North of Vista del Sol Dr. & West of Joe Battle Blvd.

City of El Paso — Plan Commission — 08/23/2018

PZR218-00015

Rezoning

Conceptual Site Plan

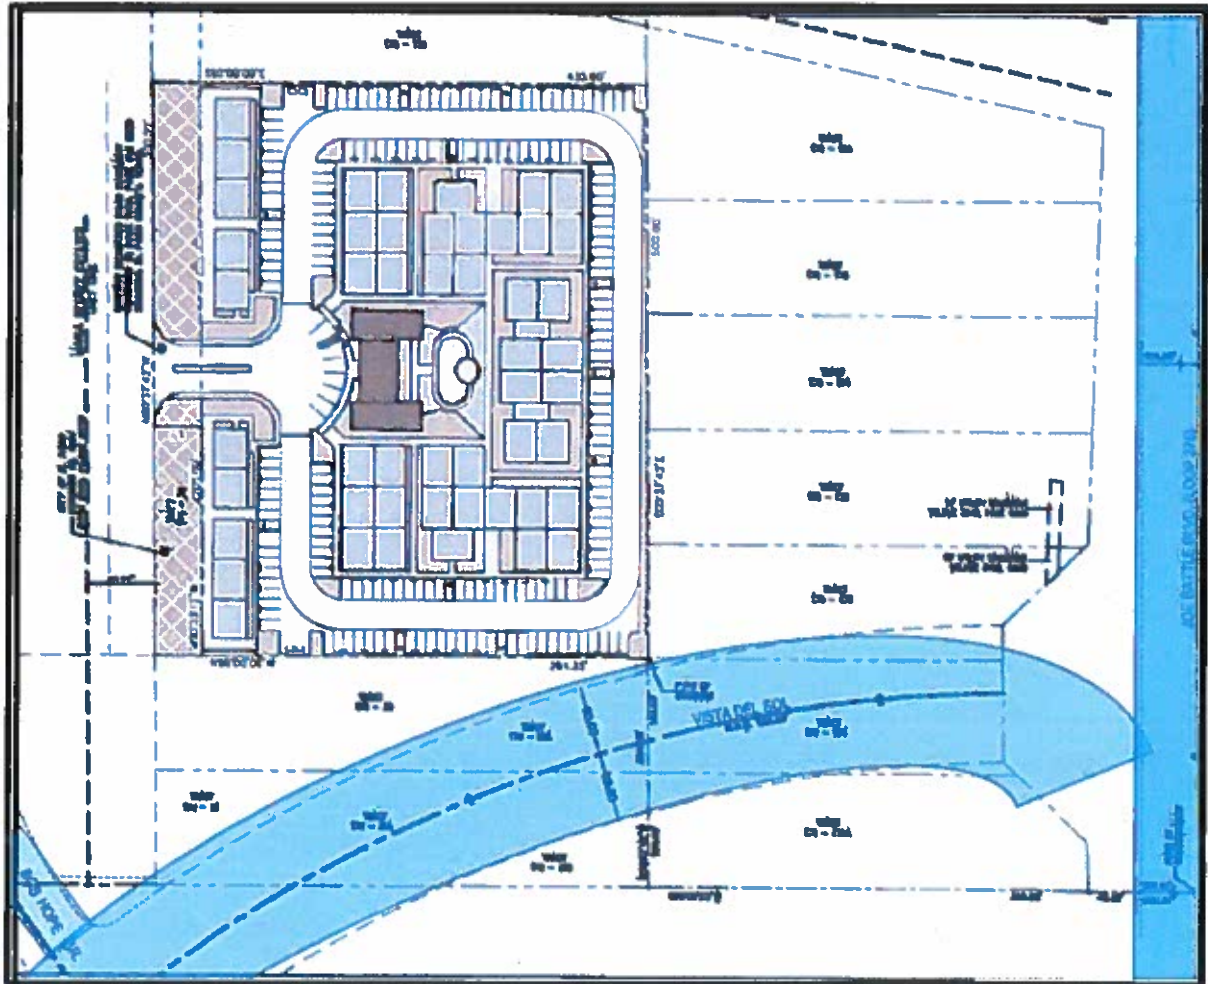
1. Add note on site plans: All Storm-water runoff discharge volumes shall be retained within this lot's limits (DSC, 19.19.010A and DDM, 11.1)."
2. Show existing and proposed drainage patterns, ponding area locations, and label all drainage structures.
3. Add current FEMA FIRM flood zone information to general notes.

Waste storage area(s) for any dumpsters will need to be identified on the plans, and will need enclosures to keep them screened from surrounding R-3. The enclosures will not be required if there is a six-ft. rock wall between the C-1 and R-3 parcels.
